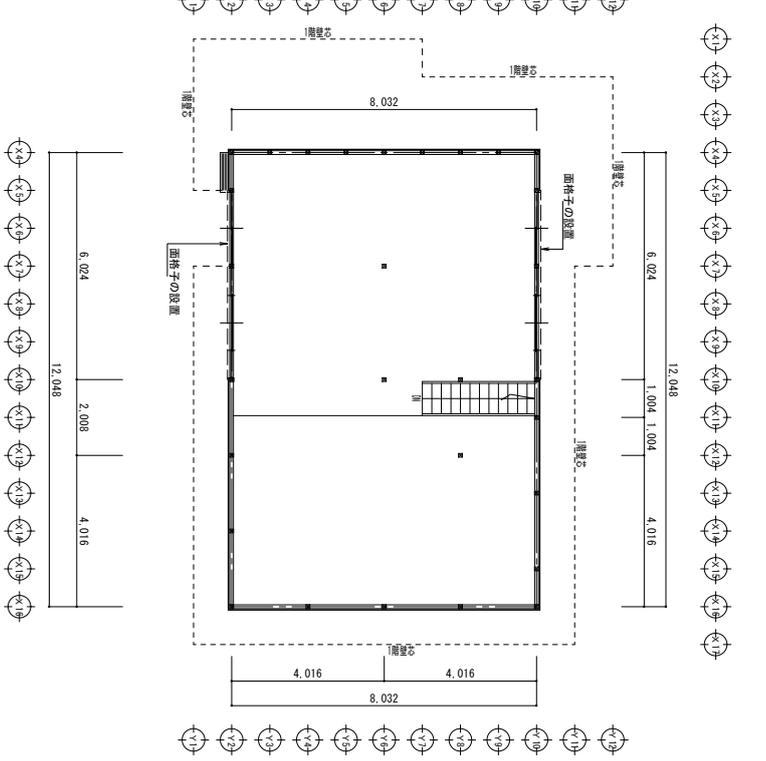
- 付加変更部分
- ・床組工事無し
 - ・空調配管
 - ・電気配管
 - ・壁空調部の撤去
 - ・1階水廻りの変更
 - ・F・F行列の変更
 - ・etc...
